Renovate Bulmer Marvin Quadrangle  
Hudson Valley Community College  
80 Vandenburg Avenue, Troy, NY  
2 March 2007  
(Bid 2973)

# ADDENDUM # 1

ASKL1

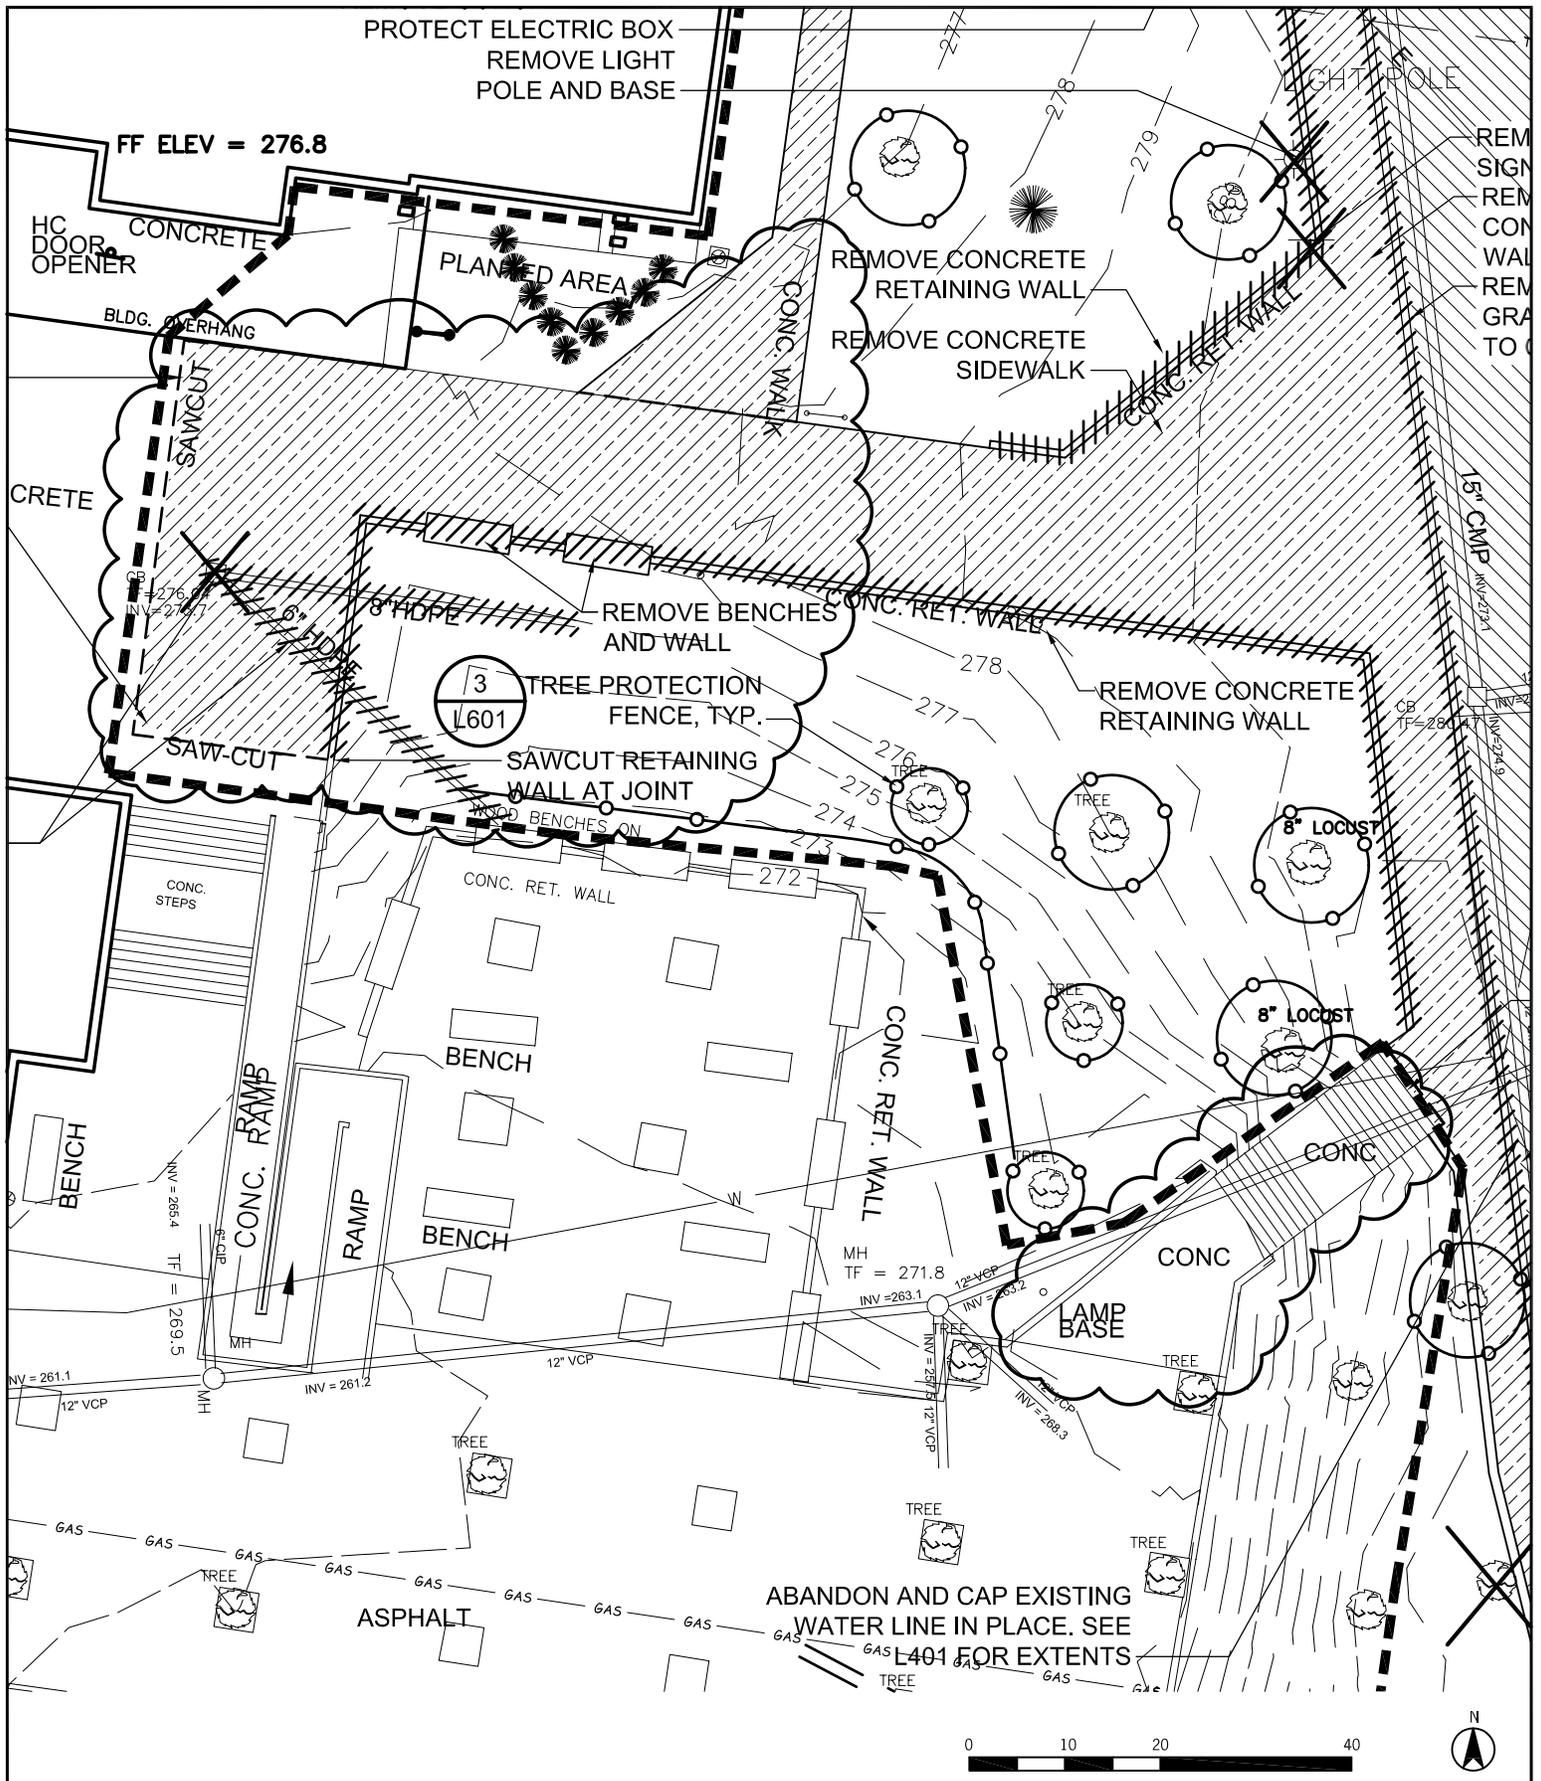
<i>Item #</i>	<i>Drawing #</i>	<i>Changes to the Drawings</i>
5.	All Drawings	<b>CHANGE:</b> All Contract Limit Lines to conform with the Contract Limit Lines shown on Drawing ASKL1
6.	L100, L101, L200, L201, L300, 301, L400, L401	<b>ADD:</b> Note to plan: "One hundred percent (100%) of the underground utilities on campus are campus owned. Contractors shall NOT contact local utilities or municipalities relative to these systems, but shall direct all contacts to HVCC at (518) 629-7356."
7.	L200, L201	<b>ADD:</b> The following after the word "where" to concrete pavement demolition note in Demolition Schedule: "landscape areas are proposed, see L300 and L301."

**ASKL5**

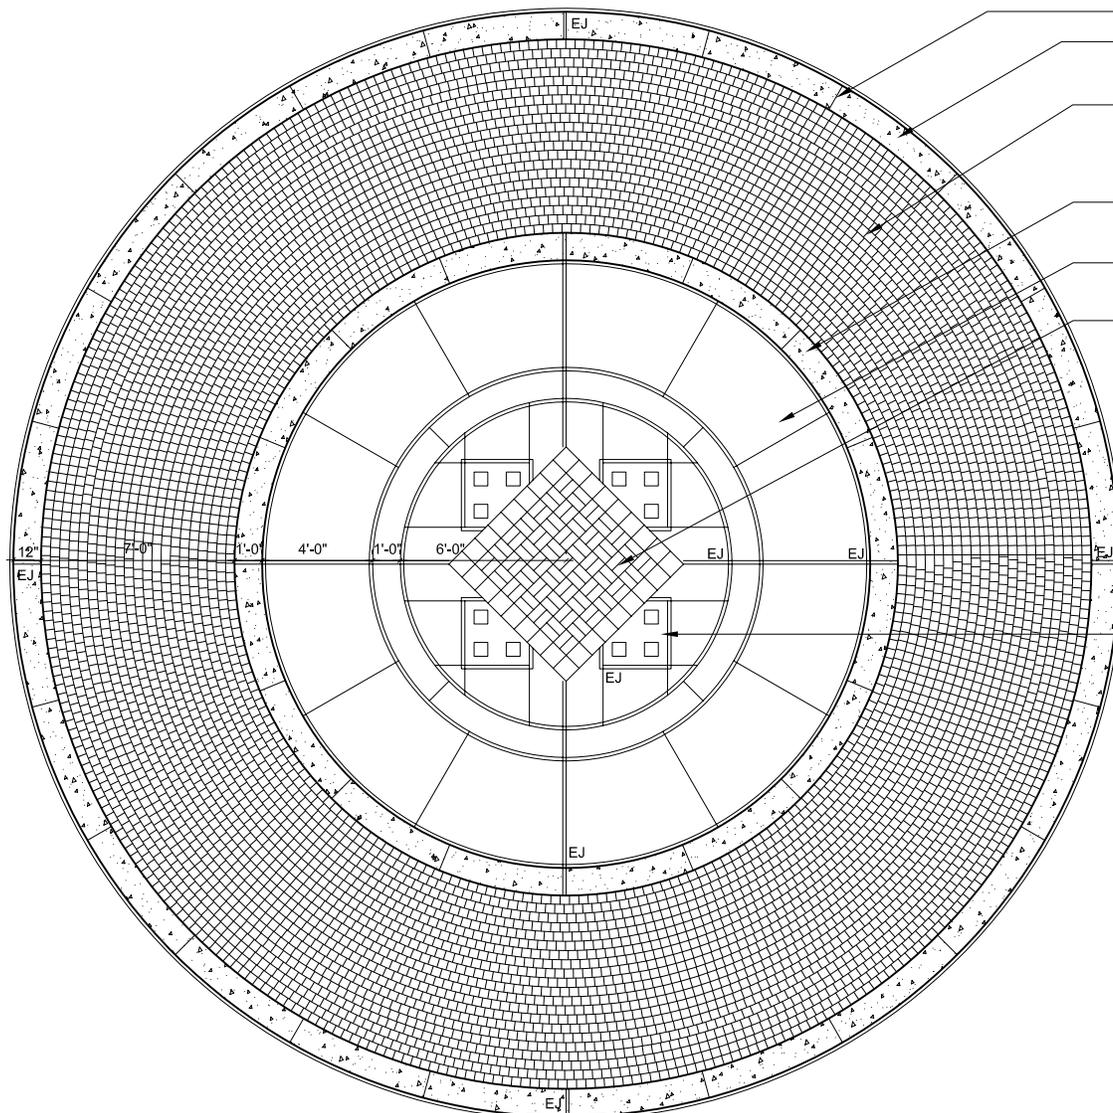
24.	L401	<b>CHANGE:</b> Plan as shown on Drawing ASKL5
25.	L600	<b>DELETE:</b> Detail 2
26.	L600	<b>CHANGE:</b> Detail 14 as shown Drawing ASKL6
27.	L600	<b>ADD:</b> Detail 4A as shown on Drawing ASKL7.

ASKL8

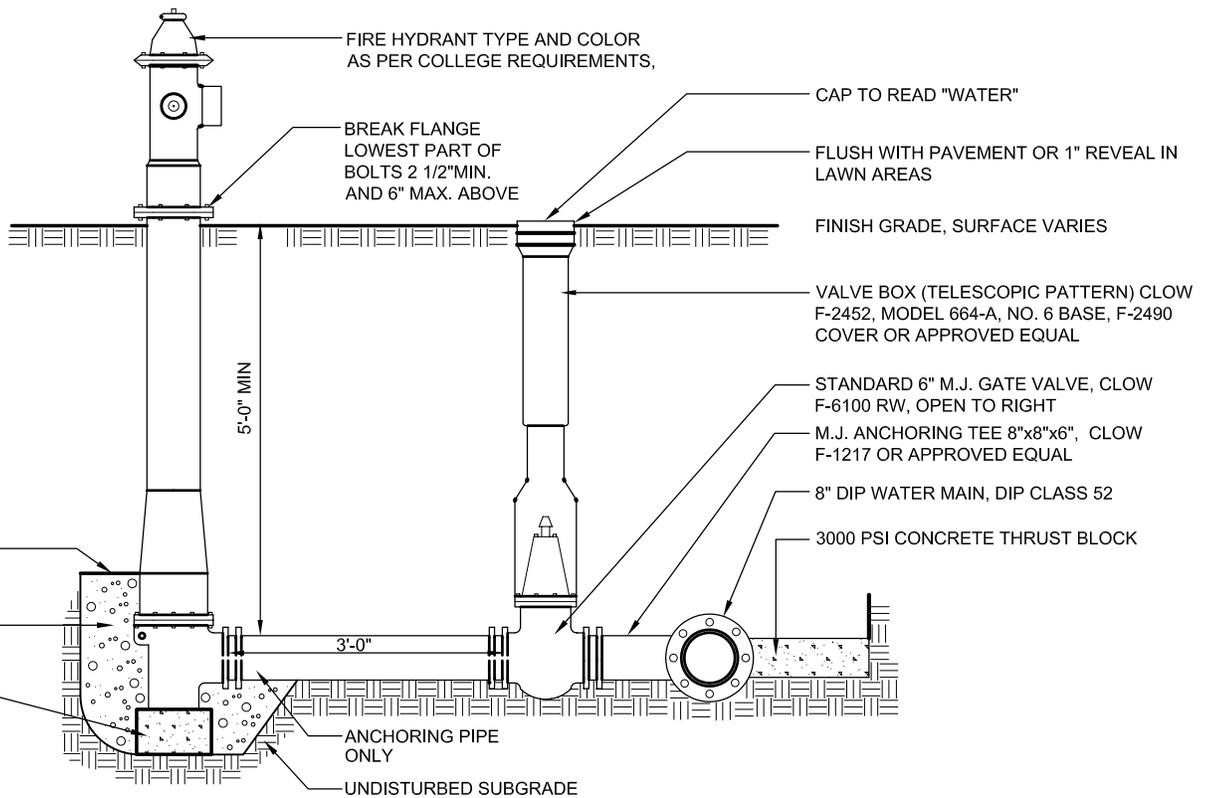
28.	L601	<b>CHANGE:</b> Detail 6 from Catch Basin Type 1 to Catch Basin Type 2 and Detail 7 from Catch Basin Type 2 to Catch Basin Type 1.
29.	L602	<b>ADD:</b> Detail 6 as shown on Drawing ASKL8

**4A** CONCRETE PAVEMENT AT BUILDING ENTRY  
NOT TO SCALE

6 TYPICAL FIRE HYDRANT INSTALLATION  
NOT TO SCALE

ASKL10

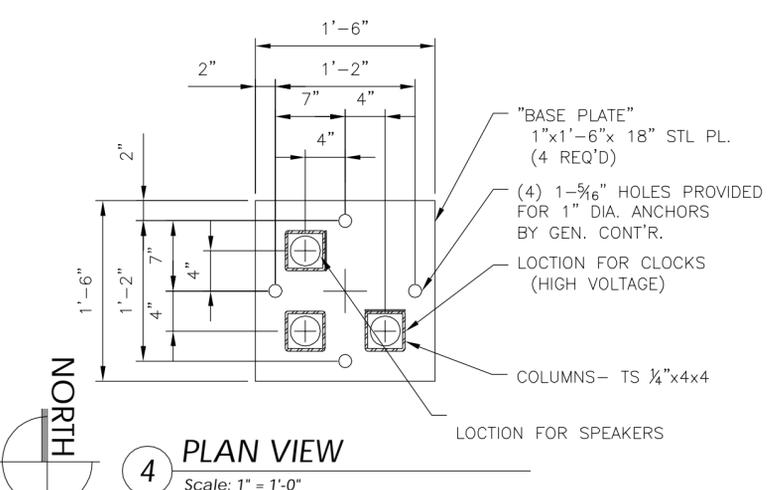
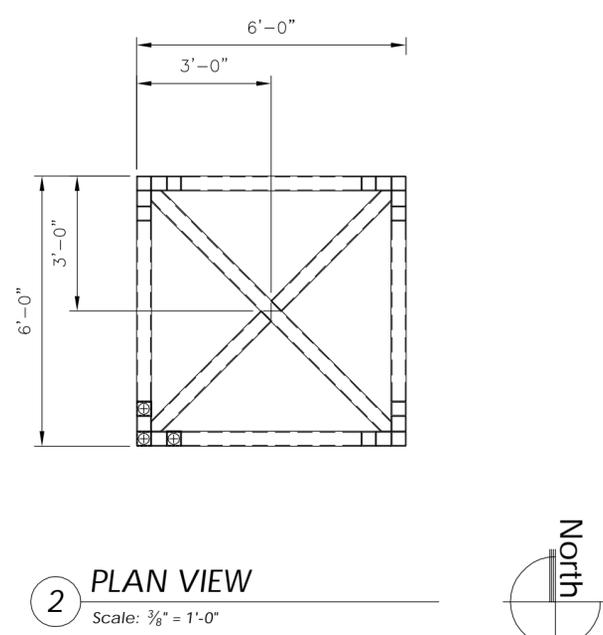
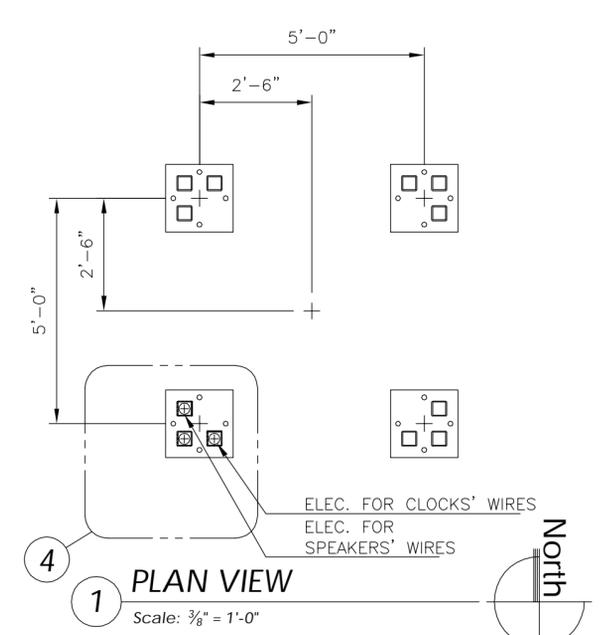
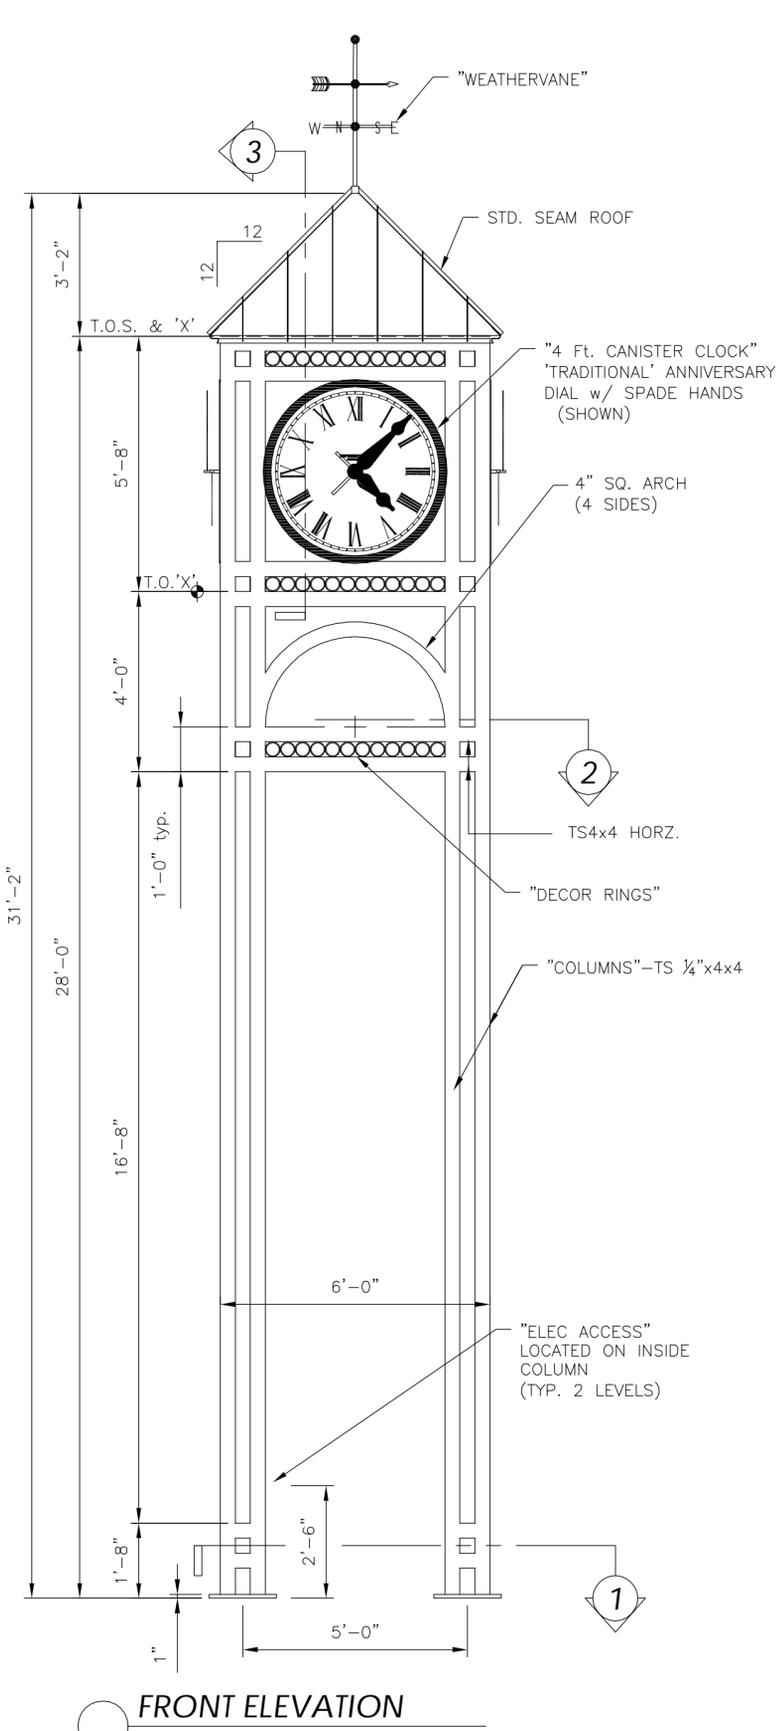
20.	L301	<b>CHANGE:</b> Plan as shown on Drawings ASKL9 and ASKL10
21.	L400, L401	<b>CHANGE:</b> All existing catch basin rims noted to be raised shall be changed to a solid cover (noted) or a pedestrian acceptable grate.
